CONSTRUCTION SUMMARY

Summer Ridge Estates Inc.

LOT NUMBER	PHASE	HOUSE TYPE	CLOSING DATE
024 Block 292	1	ROSE GARDEN (25-02-A1) ELEV A1	04-Feb-26

* INTERIOR COLOUR SCHEME *

BASEMENT PLAN ELEV 'A1' (REV.)

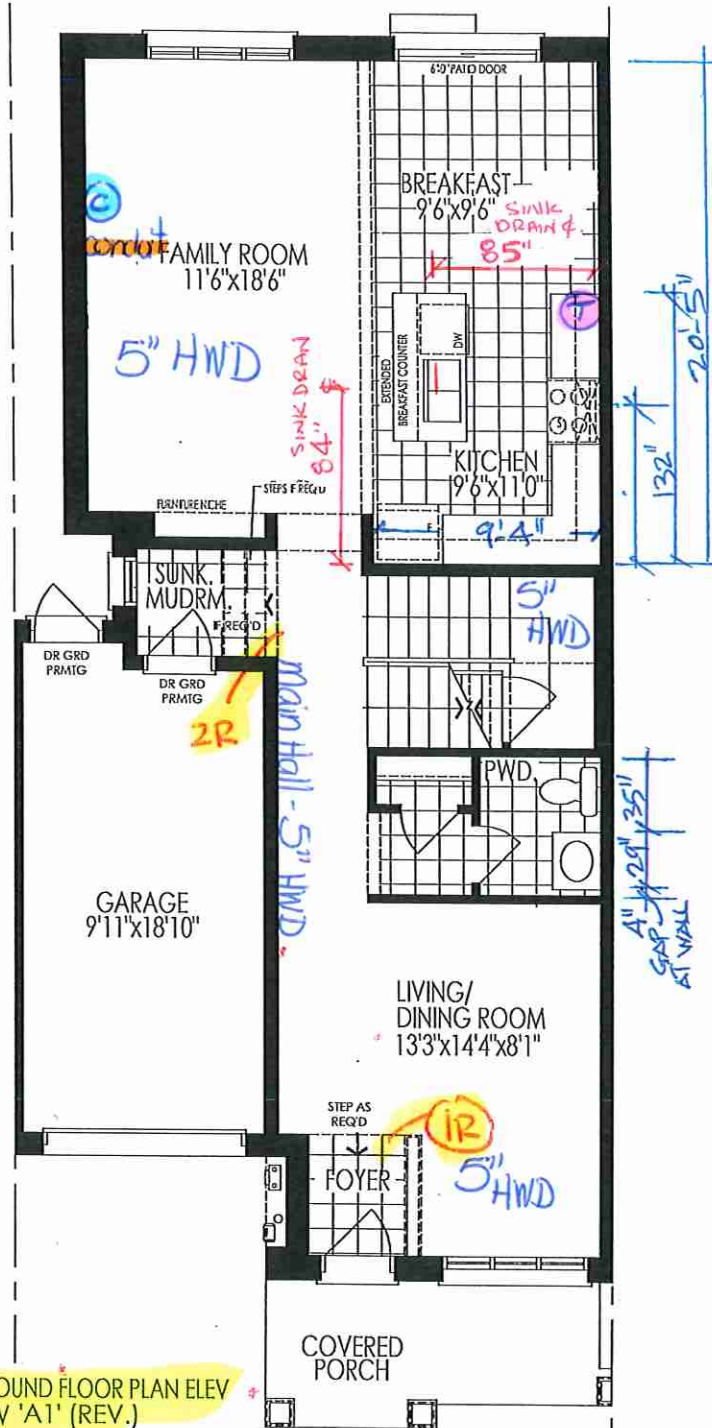
1 - BASEMENT - Install UPGRADE 200 AMP SERVICE in lieu of builders standard 100 Amp (See Sketch)
Note:

GROUND FLOOR PLAN ELEV 'A1' (REV.)

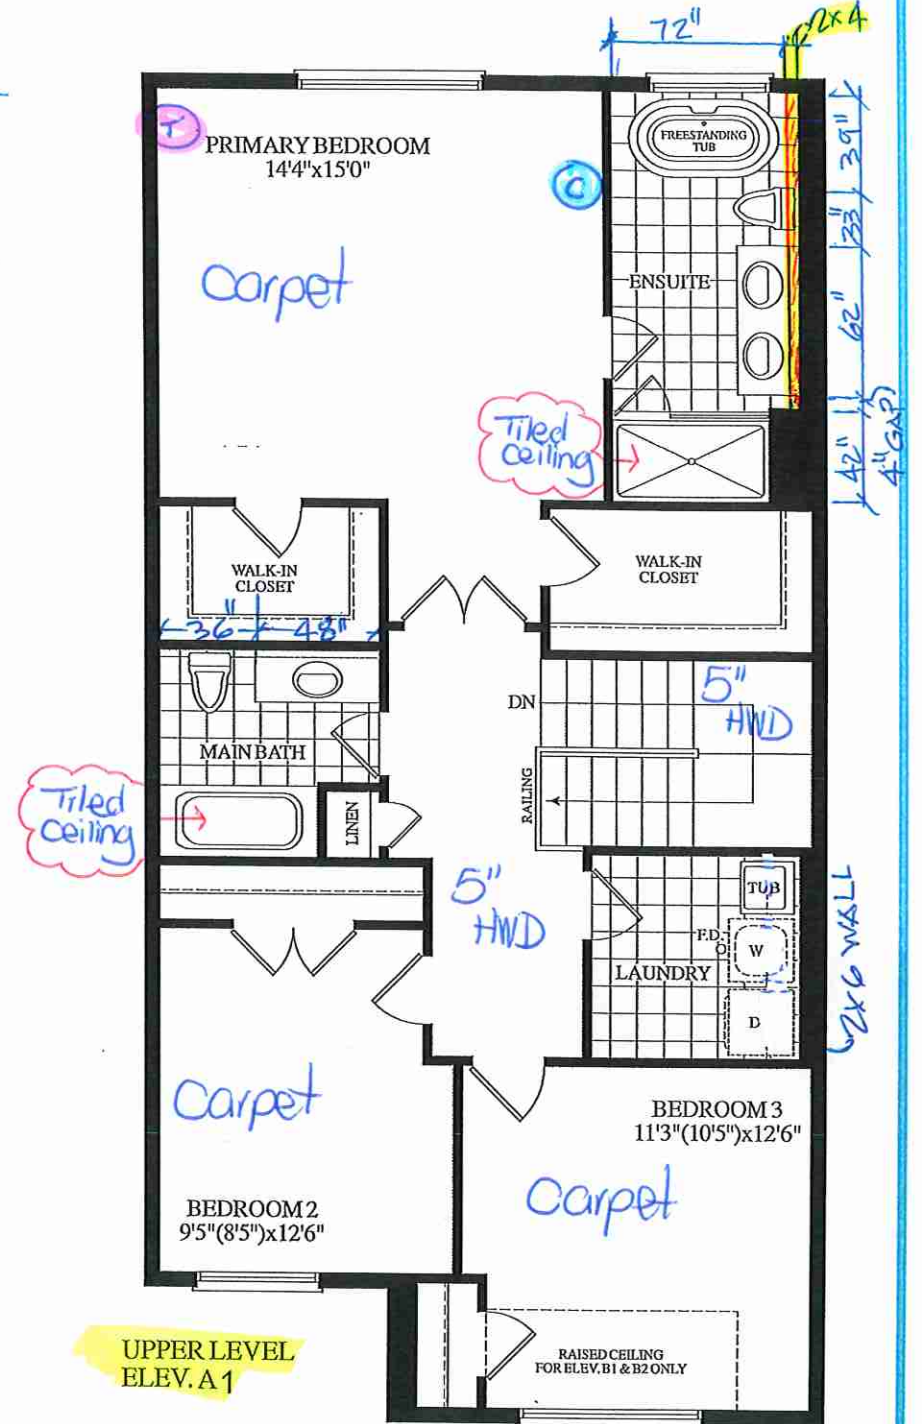
1 - MAIN FLOOR & 2ND FLOOR - INTERIOR DOORS - Install UPGRADE Interior Door Style - LINCOLN PARK, SMOOTH (Standard Height) - To be installed throughout main floor and 2nd floor, where applicable (See Sketch)

1 - MAIN FLOOR & UPPER HALL - FLOORING - HARDWOOD - Install prefinished 5" x 3/4" VINTAGE WHITE OAK BAROQUE (Character Pearl) in lieu of builders standard prefinished 3 1/4" x 3/4" Vintage Red Oak Natural Hardwood.

Note: To be installed throughout main floor and upper hall, where applicable. To Include; LivingRoom / DiningRoom, Main Hall, Family Room, Upper Hall and Applicable Landings (See Sketch)

1 - STAIRCASE - Stain Oak Staircase from Main Floor to Second Floor, where applicable. To be Stained - Vintage Red Oak BAROQUE - To Include; Treads, Risers, Handrail and Post, where applicable (See Sketch)

KITCHEN PLAN

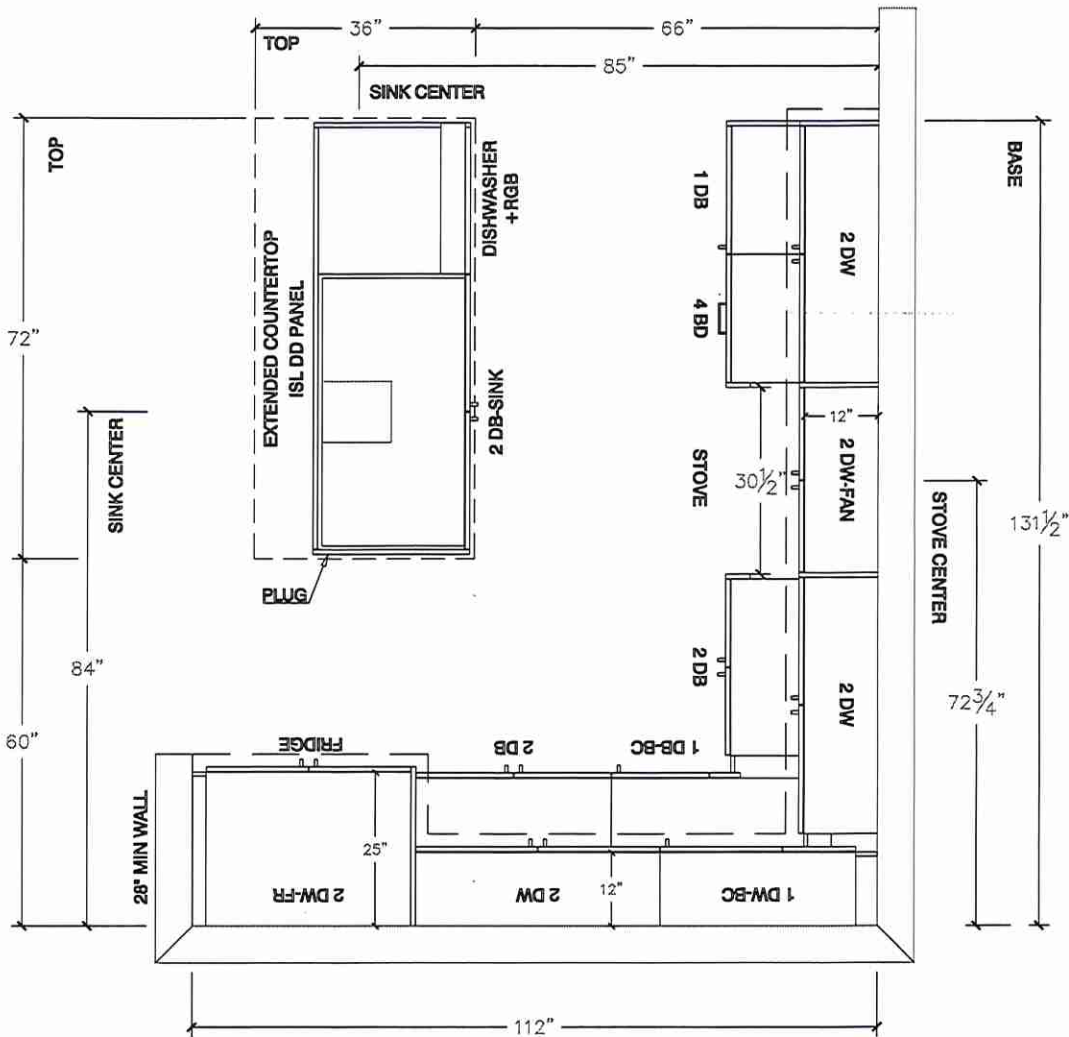
1 - KITCHEN & BATHROOMS - Purchaser has DECLINED All Upgrades offered during decor appointment at the decor centre for kitchen & bathroom cabinetry. Standard Kitchen Layout & Standard Bathroom Vanities to be installed as per standard plan. (See Sketch)

1 - KITCHEN - COUNTERTOP - Install UPGRADE #2 Stone Countertop – EVEREST WHITE SHIMMER - To be installed throughout kitchen, where applicable (does not include stone backsplash) (See Sketch)

1 - KITCHEN - COUNTERTOP EDGE - Install UPGRADE " L " EDGE PROFILE - To be installed throughout kitchen countertop, where applicable (See Sketch)
